GOVERNMENT OF THE DISTRICT OF COLUMBIA
DEPARTMENT OF TRANSPORTATION

MEMORANDUM

DATE: November 24, 2015

SUBJECT: **BZA Case No. 19121** – Capitol Point South: 51 N St., 1250 1st St., and 50 Patterson St. NE

Figure 1: Site Design and Access (Source: Grove/Slade Associates)

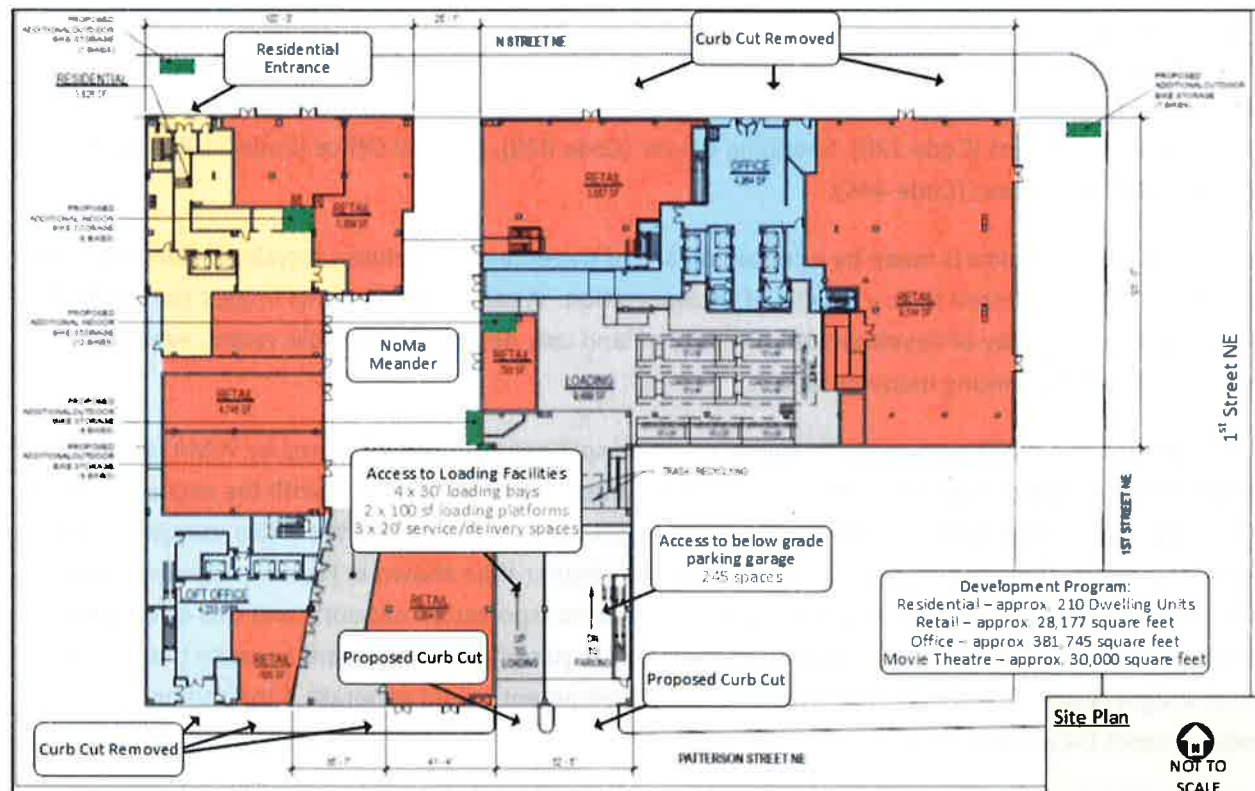
The Applicant proposes off-street parking and loading access to the site through two separate curb cuts

on Patterson Street (see Figure 1). Access to the site from Patterson Street is appropriate. While these two curb cuts do not meet DDOT standards for distance between curb cuts, the Applicant has demonstrated that the two curb cuts cannot be located a minimum of 32' apart or combined to a single 24' curb cut for simultaneous access to loading and parking. The Applicant has already applied for conceptual approval of a public space permit for the two curb cuts and been approved by the Public Space Committee.

Figure 7: Parking Restrictions (Source: Grove/Slade)

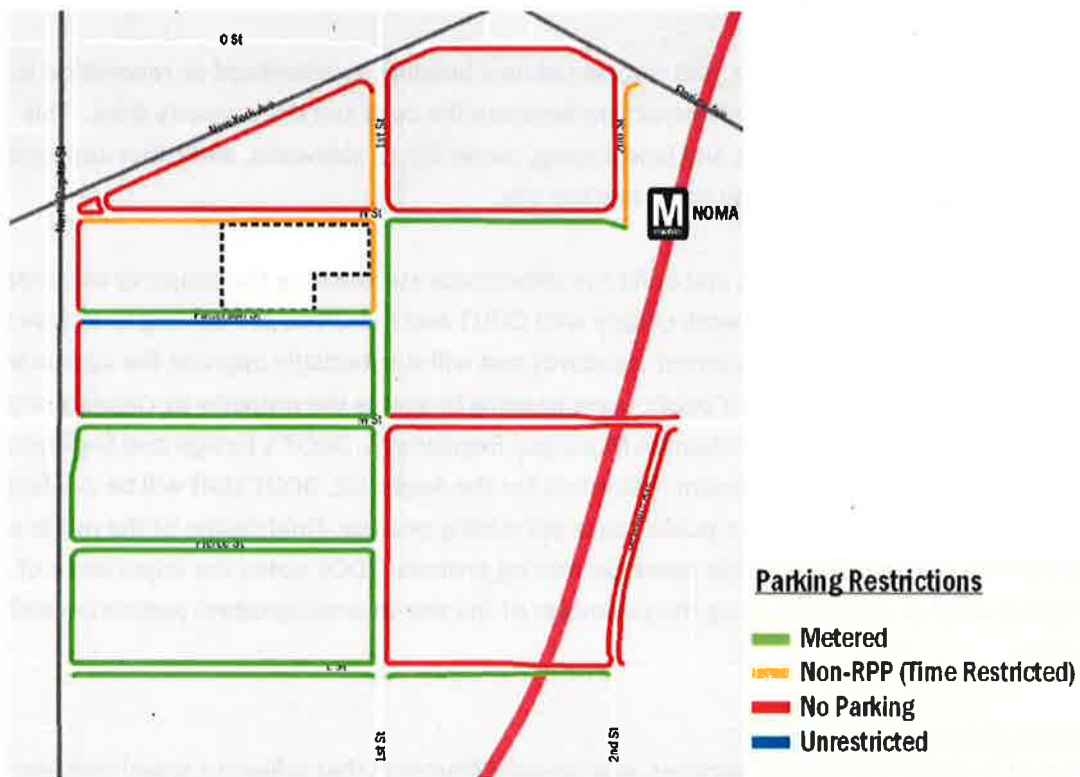
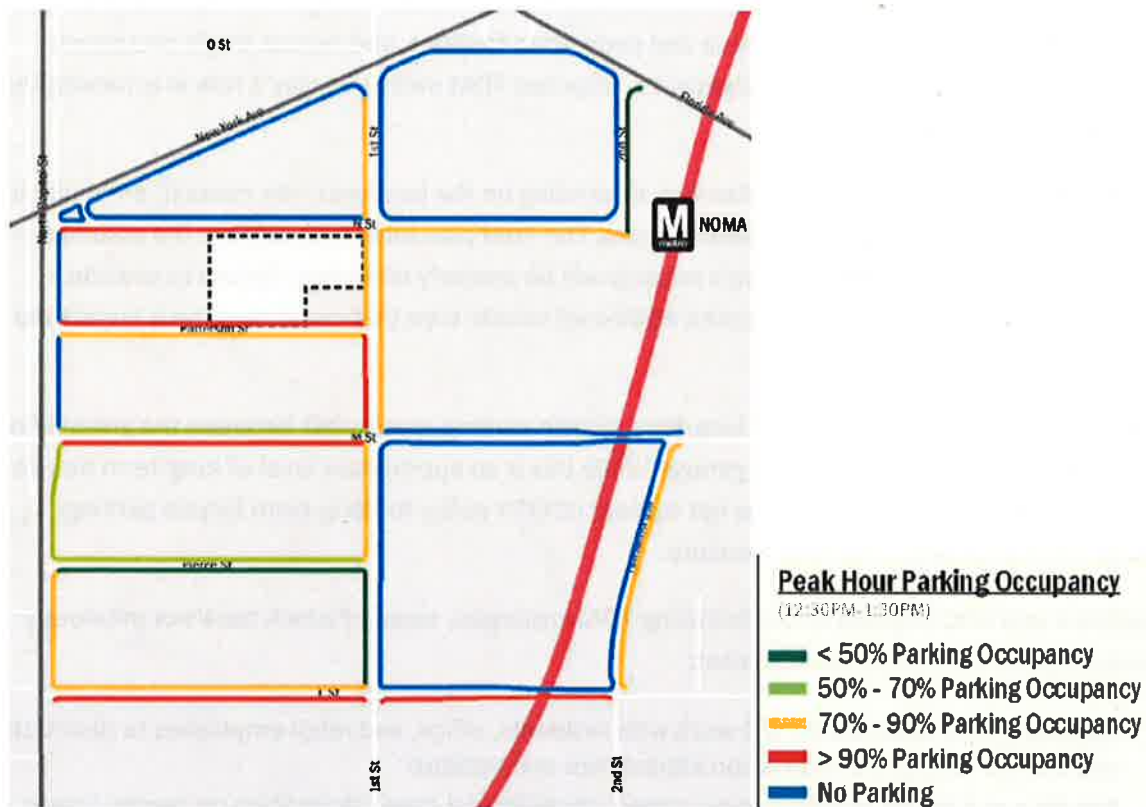
A vehicle parking occupancy study was conducted by the Applicant. Parking occupancy data was collected on Friday, November 10, 2015 from 7:30 am to 9:30 pm when street sweeping was not scheduled for the day. This analysis shows unused nearby on-street parking (see Figures 5, 6, 7, and 8), with 87 spaces available during peak weekday demand in the study area (12:30 pm to 1:30 pm). The Applicant noted that due to ongoing construction in the vicinity of the site, many of the parking spaces were cordoned off during the parking occupancy study, and a higher number of total spaces would be available once construction is complete. DDOT finds that the on-street vehicle parking supply, which is predominantly metered, is generally available during weekdays from 7:30 am to 9:30 pm
